### SUMMARY OF CONSULTATIONS

### CONSULTATION RESPONSE

No.	Stage	Consultee	Comment	LCC Comment and SPD Response
<b>AREA NAME – HOLBECK URBAN VILLAGE</b>				
1	Formal via e-mail and letter	CEG	The Council has proposed to rename the revised guidance ‘Holbeck Urban Village, South Bank SPD’, presumably to reflect the location of Holbeck within the southern half of Leeds City Centre, and the significant contribution that this area will make to wider regeneration of the South Bank. Indeed, the main title page of the SPD refers to ‘Holbeck, South Bank’.  ‘Holbeck, South Bank Leeds’ is considered to provide a more appropriate	<u>LCC Comment:</u> Comment noted. Primarily, this is not specifically a Planning matter and does not impact on the Planning Policy. However,

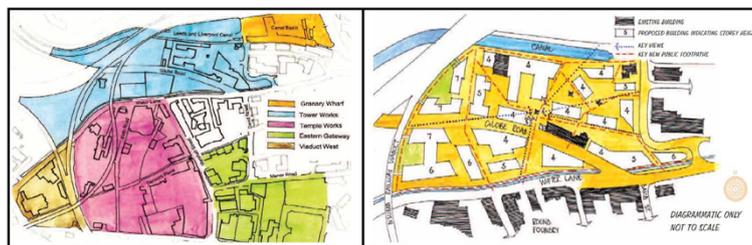
The existing HUV Revised Planning Framework (February 2006) includes the Site within its boundary. This Framework identifies five areas that make up the HUV, with the Site falling within the 'Tower Works' area. However, the detailed plan for the Tower Works area extends no further westwards than the existing railway viaduct (**Figure 2** below).

The Site continues to fall within the Tower Works area within the Consultation Draft.

Evidently the Site is not seen as a critical component to the role and function of the Tower Works area, or the HUV.

<p>The Council have subsequently confirmed (at a meeting between CBRE and Leeds City Council on 20 March 2015) that Officers do not see the bridge as a necessary in this location, given the Green Bank Site is already accessible. The Green Bank Site already benefits from good connections to the Whitehall Riverside area via Globe Road and Whitehall Road. The latter also provides excellent connections between both sides of the Leeds and Liverpool Canal within a short walking distance.</p> <p>The Site is a peripheral location within the HUV. A footbridge would be physically separated from the HUV core and would not provide the most accessible north-south routes that the SPD requires. If a footbridge is deemed appropriate and necessary to link Holbeck with the Whitehall Riverside area, it would clearly be better suited and more commodious to create a route in to a more central location within the Tower Works area.</p> <p><b>c) Conclusions</b></p> <p>These representations are submitted on behalf of Taylor Wimpey UK in regards to Leeds City Council's Holbeck Urban Village (HUV) Supplementary Planning Document (SPD) Consultation Draft. They relate to land forming the eastern part of the 'Green Bank Site', situated within the north-west of the Holbeck Urban Village (HUV) boundary.</p> <p>As our representations have set out above, the Site does not fit within the overall framework for the HUV and is physically separated from this area. It is not appropriate to be included in the HUV boundary, nor does it serve any sound planning purpose for the following reasons:</p> <ol style="list-style-type: none"> <li>1. The Site functions as part of the wider Green Bank Site, rather than the HUV. The majority of the Green Bank Site falls outside of the HUV boundary, and the Site is essential to deliver its comprehensive, mixed-use development in the future;</li> <li>2. The Site is physically separated from the HUV by the existing viaduct;</li> <li>3. The SPD suggests the Site should accommodate a footpath crossing over the Liverpool and Leeds Canal. This would be unsuitable in this peripheral location, and would be better located more centrally within the HUV. Indeed, Officers have indicated that this is no longer required at the Site;</li> <li>4. There is a strong pedestrian link between the Whitehall area and Holbeck along Globe Road which provides an excellent access between the 2 areas, and there is no need for the pedestrian crossing.</li> </ol> <p>The removal of the Site from the HUV boundary would ensure that the SPD is based on the most appropriate strategy for future development. Its removal would not impact upon the vision or strategic objectives for the HUV area.</p> <p>We therefore suggest that the boundary is redefined in the north-west area to adopt the railway viaduct as its maximum extent.</p>
